TECHNICAL MEMORANDUM

Reference No. PS139771-001-TM-Rev0

AMITY FLOW SLIDE BARRIER – GEOPHYSICAL SURVEY COMMENTS AND UPDATES

PROJECT		GEOPHYSICAL SURVEY OF FLOW-SLIDE BARRIER AMITY POINT, NORTH STRADBROKE ISLAND	
TITLE		ROCK ARMOUR EXTENTS PLAN AND CROSS SECTION LOCATIONS	
PROJECT NO.	CONTROL	REV.	FIGURE
PS139771	001	0	B1

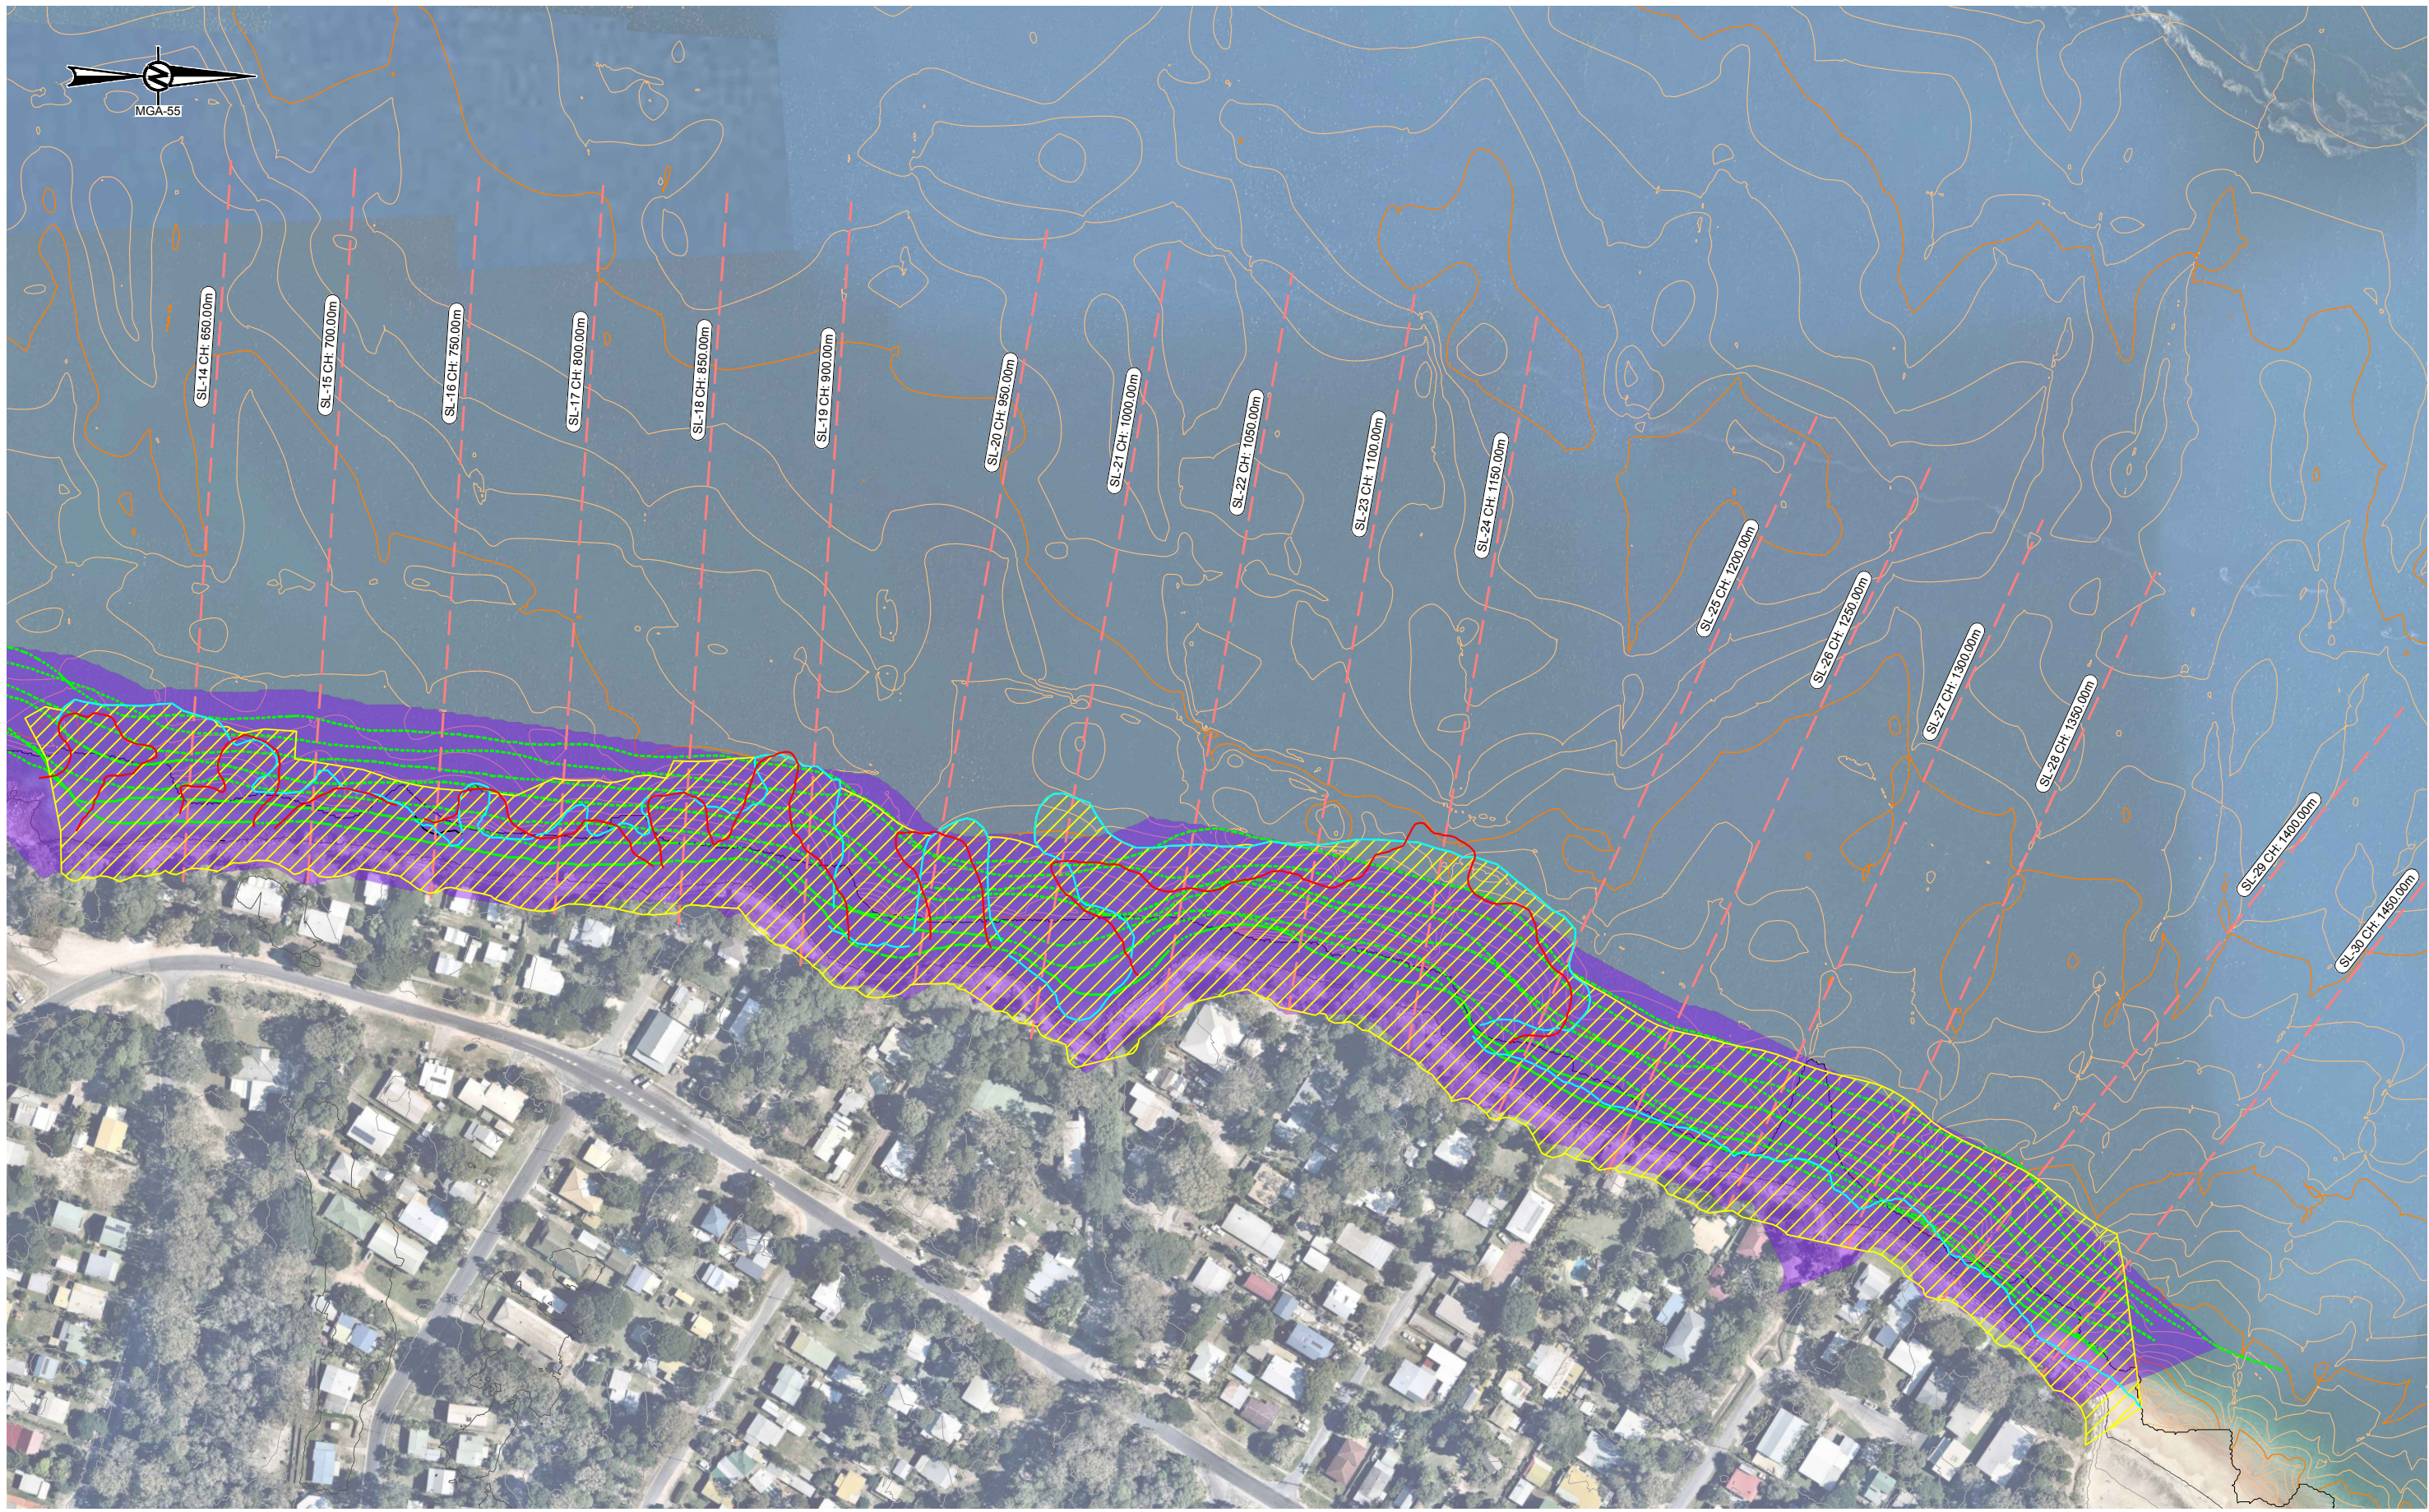
A review of the comparison plan view provided in Figure B1 indicates that the extent of interpreted boulder material and mixed sand and boulder materials between the two surveys, shown as purple shaded areas for 2022 and as yellow hatched areas for 2017, show general agreement. The extents of interpreted materials for the 2022 survey are generally slightly increased compared to the 2017 survey, particularly to the south of the survey area between CH 650 to CH 850. These changes may be related to either movement in FSB materials or variations in survey results such as differences in equipment sensitivity and accuracy, line positioning, interpretation of results, or a combination of both.

The interpreted seaward toe of the sea wall, as observed in the side scan sonar data from the corresponding geophysics surveys, is also generally consistent between the two surveys (2017 survey shown by blue line, 2022 survey shown by red line). The sea wall toe appears slightly decreased in the 2022 survey compared to the 2017 survey in some locations, particularly between CH 1000 to CH 1100, and also appears more intermittent between CH 650 to CH 700. These differences are likely explained by movement of surface sands between survey dates.

TITLE
**COMPARISON ROCK ARMOUR CROSS SECTIONS SHEET 1
OF 4**

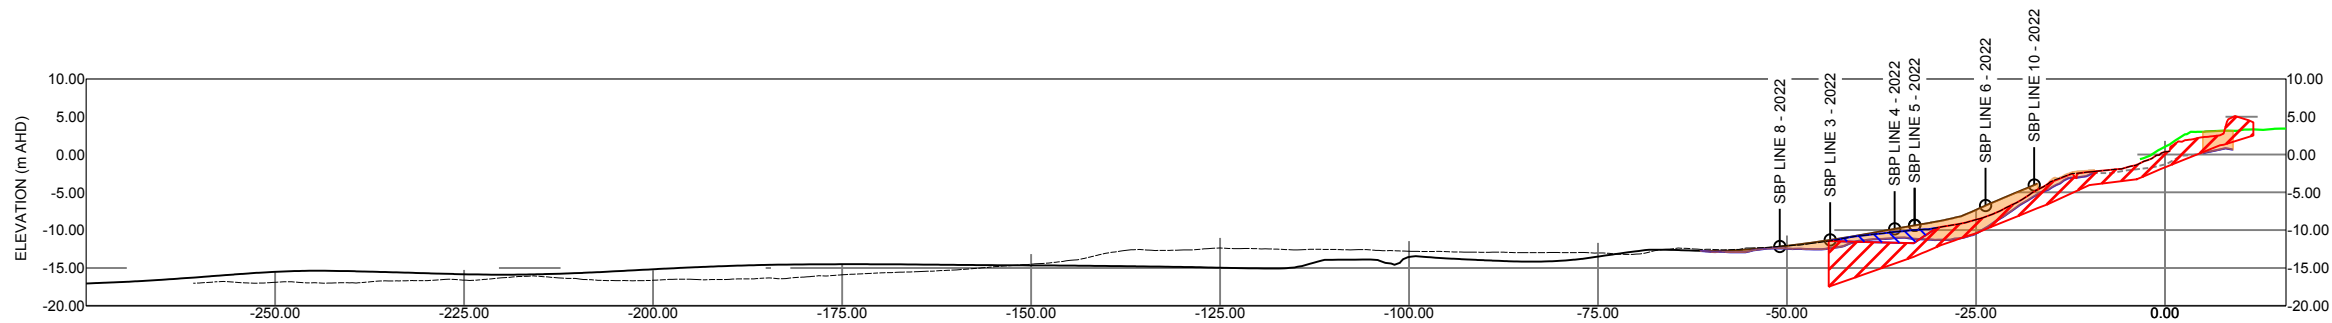
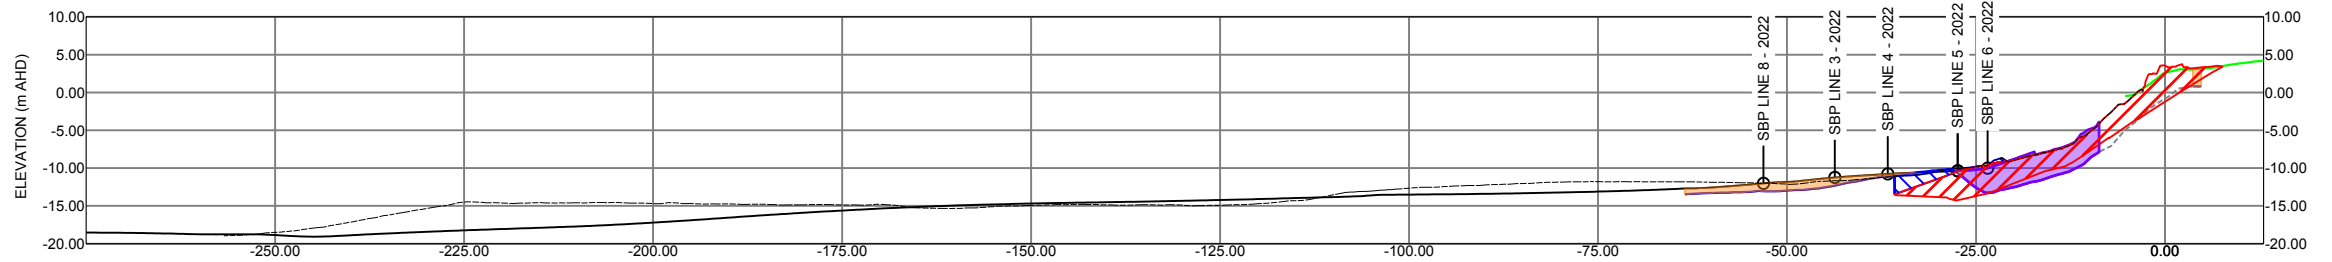
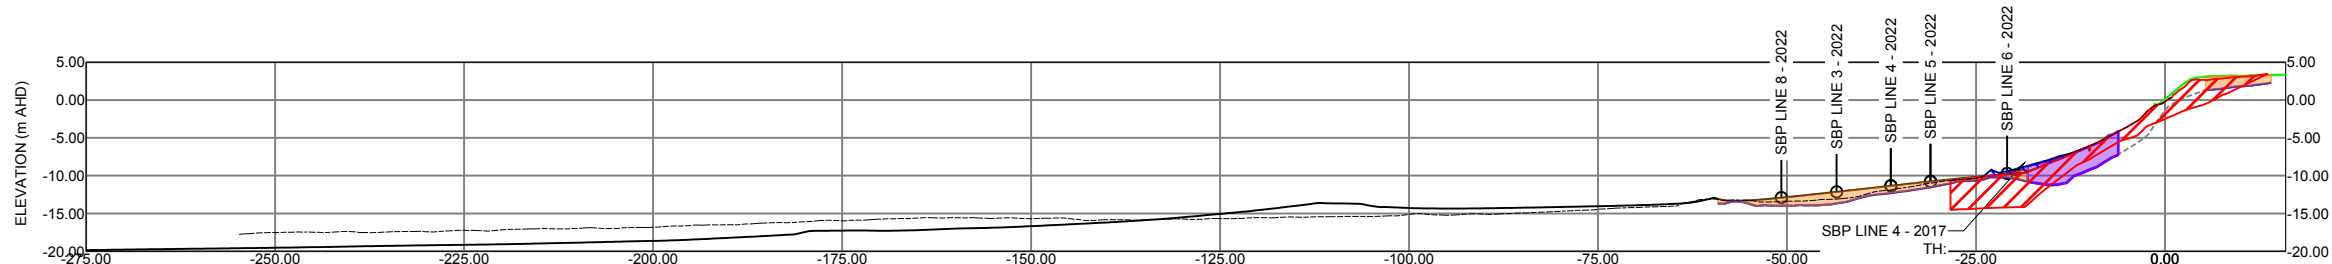
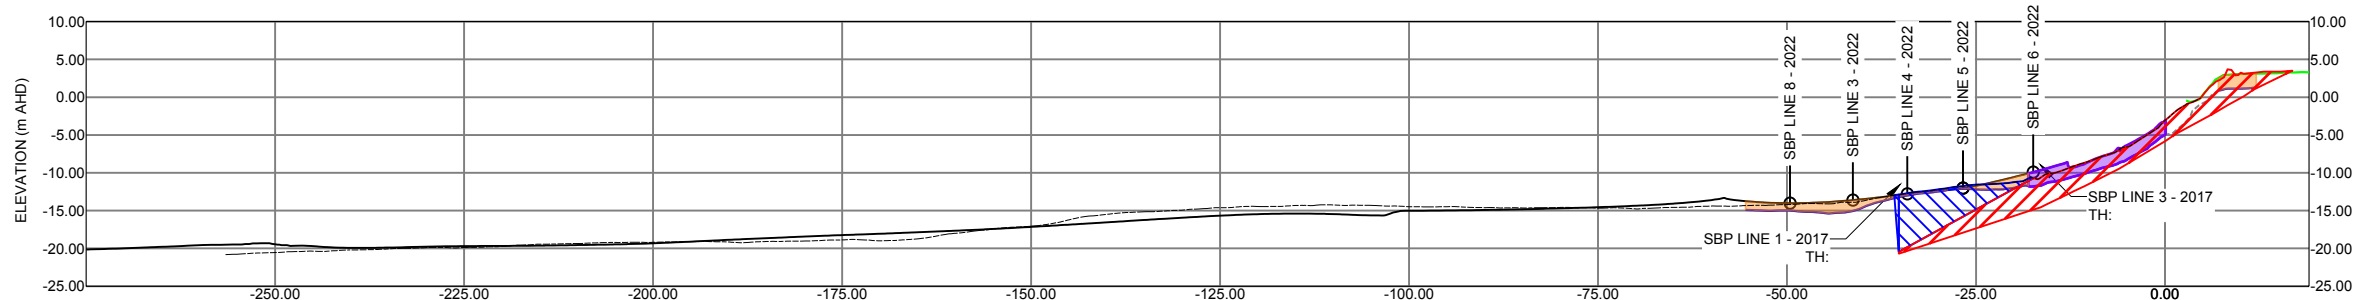
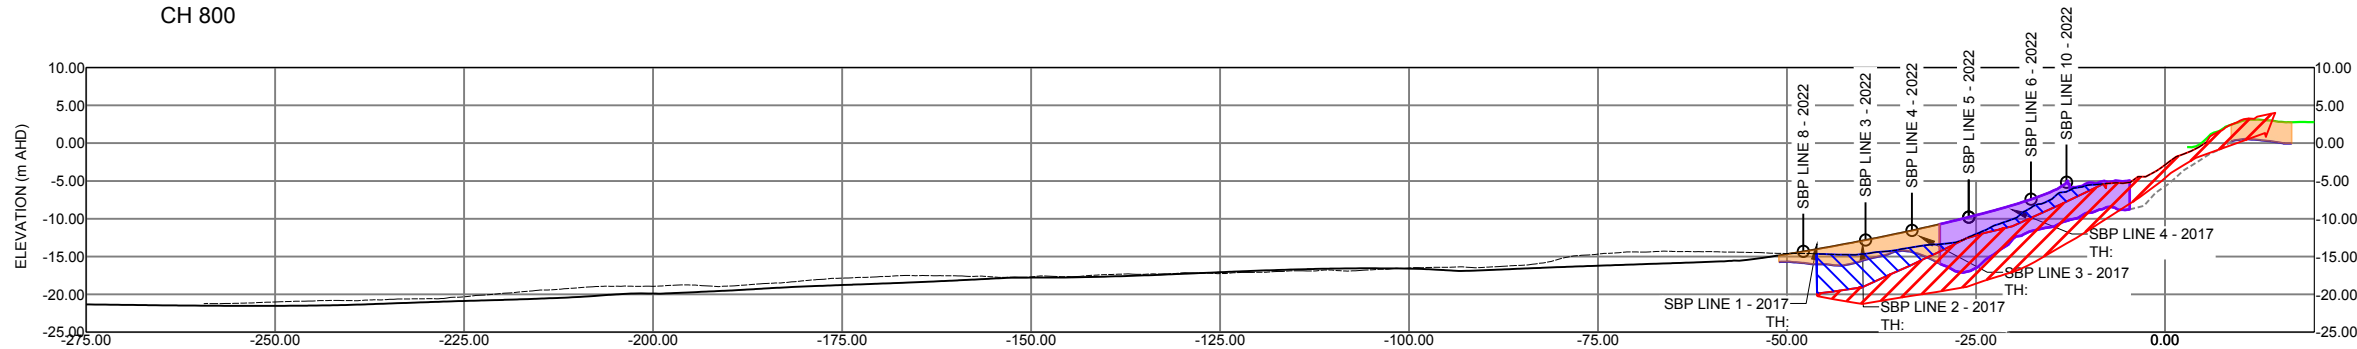
A review of the comparison cross-sections provided in Figures B2 to B5 shows the extents of the interpreted predominantly boulder material to be reduced in comparison to the 2017 survey. This may be in part due to the 2022 survey equipment and data processing identifying these areas more accurately and better delineating between the predominantly boulder material and the mixed sand and boulder materials. The thickness of the predominantly boulder material is also generally reduced in the 2022 survey results, with the exception of the sections at CH 700, CH 750, CH 850, CH 900, and CH 1100 which show comparable or greater thickness of this layer in the 2022 survey.

COMPARISON ROCK ARMOUR CROSS SECTIONS SHEET 3
OF 4

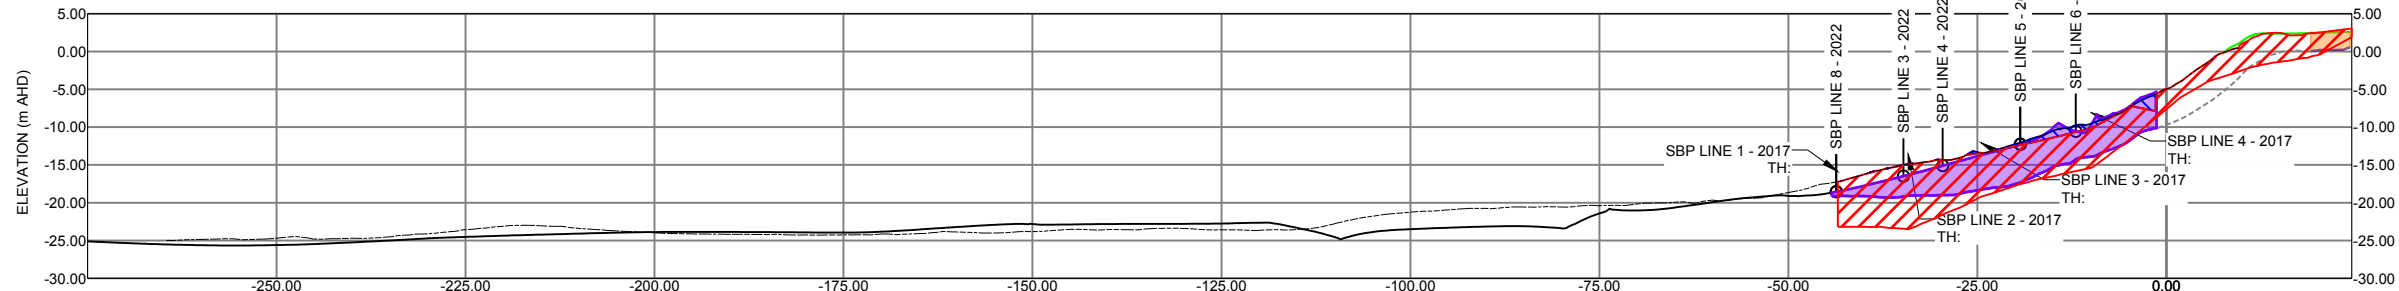
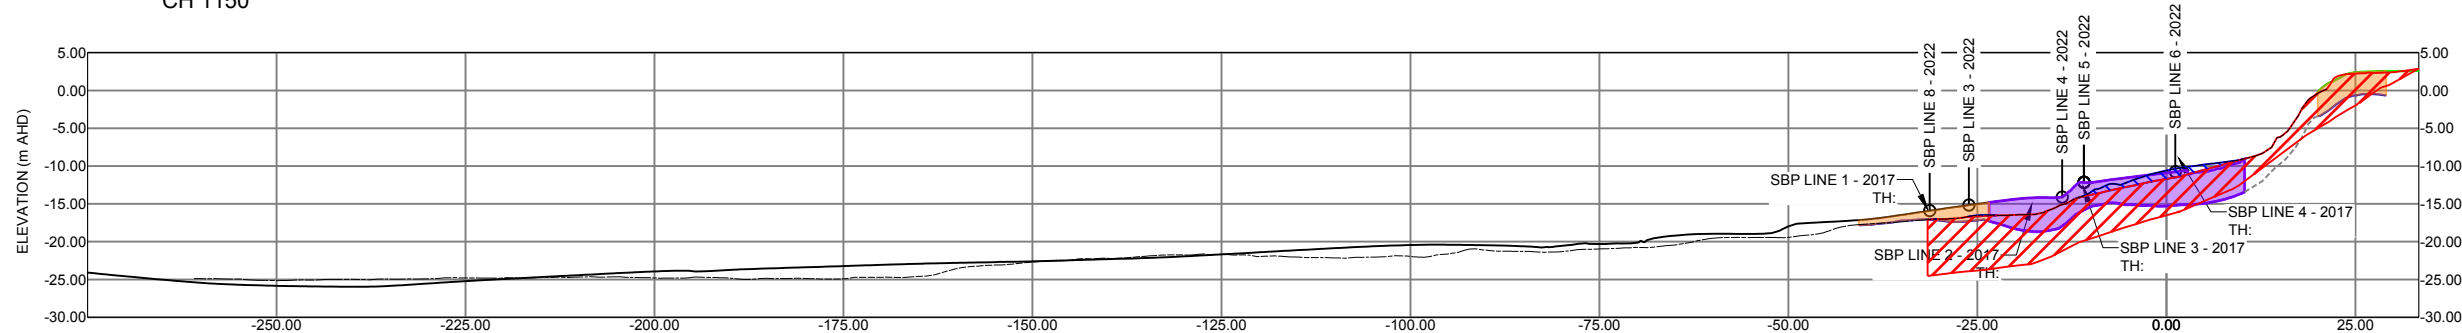
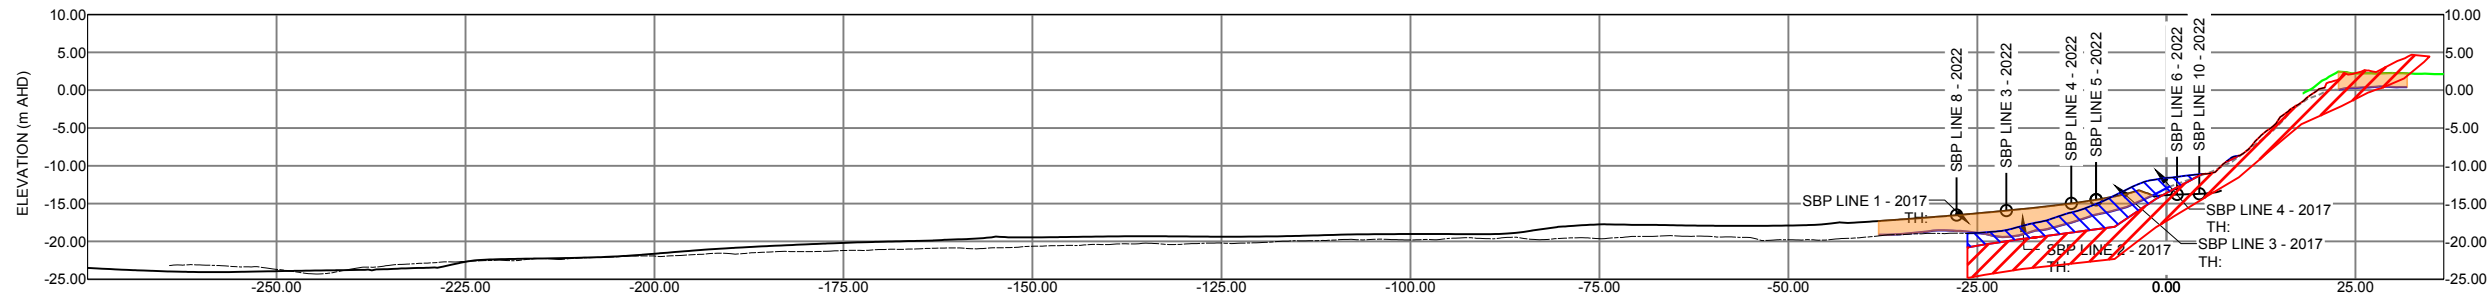
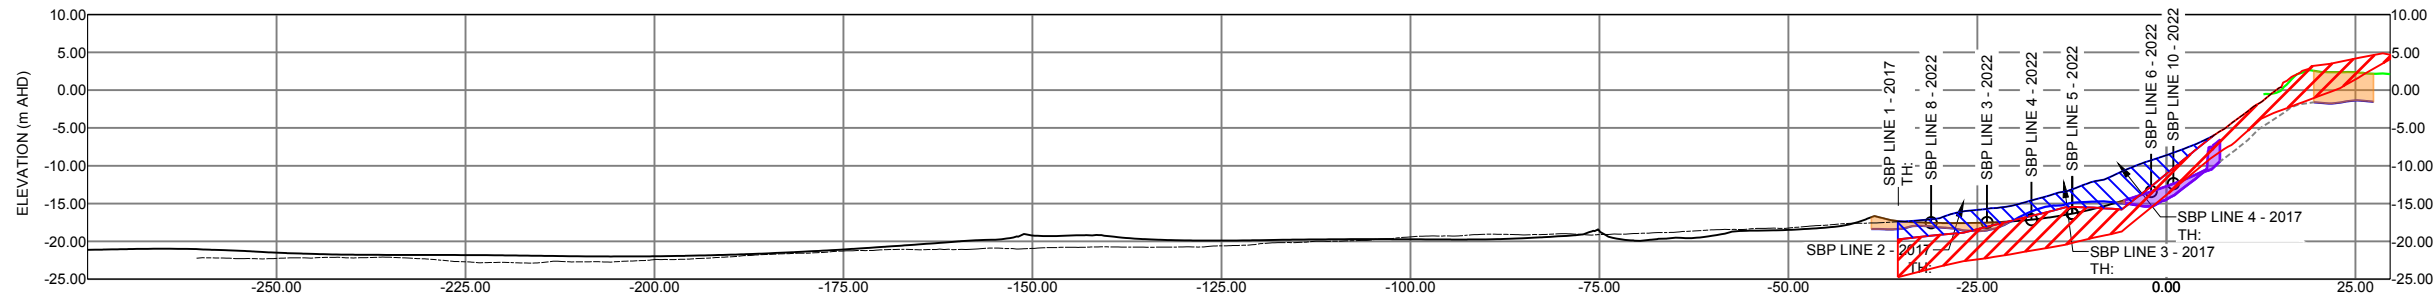
The Water Technology report indicates cross-section results at CH 1000, 1250, and 1450 failed to detect a noticeable toe or interpreted boulder material. This is generally correct for the 2022 survey, however it is noted that some interpreted boulder material was observed at these locations in the 2017 survey.
